DRAFT NATIONAL RADIO FREQUENCY PLAN 2017

INDEPENDENT COMMUNICATIONS AUTHORITY OF
SOUTH AFRICA

SENTECH thanks the Independent Communications Authority of South Africa (“Authority”) for the opportunity to make a submission on the *Draft National Radio Frequency Plan 2017* (“NRFP-17”) Government Gazette No. 40480, Notice No. 861 as published on 9 December 2016. SENTECH would like to indicate its intention to make a presentation on the date scheduled by the Authority.

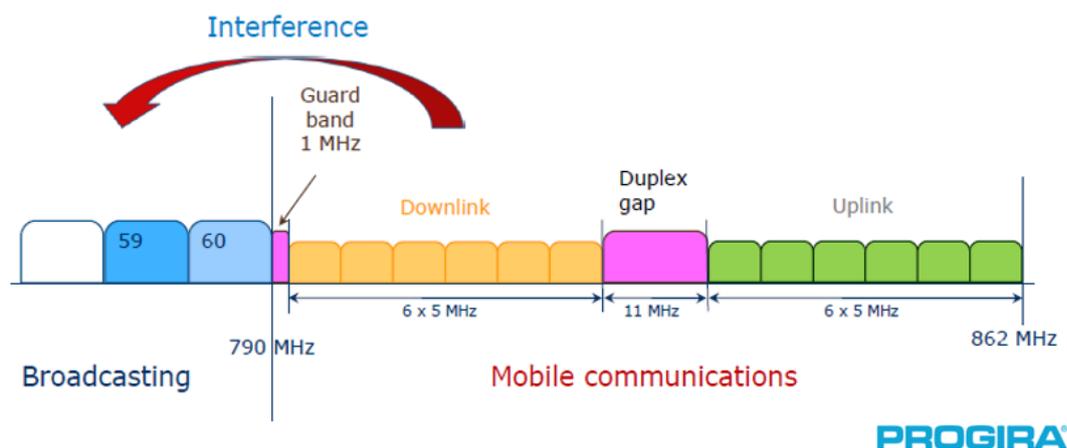
The deployment of IMT services and the adjacent channel co-existence of both services (DTT and IMT) should be in compliance with radio regulation footnote 5.317A:

The diagram below, illustrates the likely interference scenario that must be adequately managed in the event mobile services are deployed adjacent to broadcasting services in the same geographic area.

The co-primary allocation to broadcasting services in the bands 694 – 790 MHz and 790 – 862 MHz should not be removed. The introduction of mobile services can be co-ordinated. The broadcasting industry and mobile industry, under the leadership of the Authority should commence a workshop regarding coordination requirements and protocols with respect to the introduction of mobile services post-ASO.
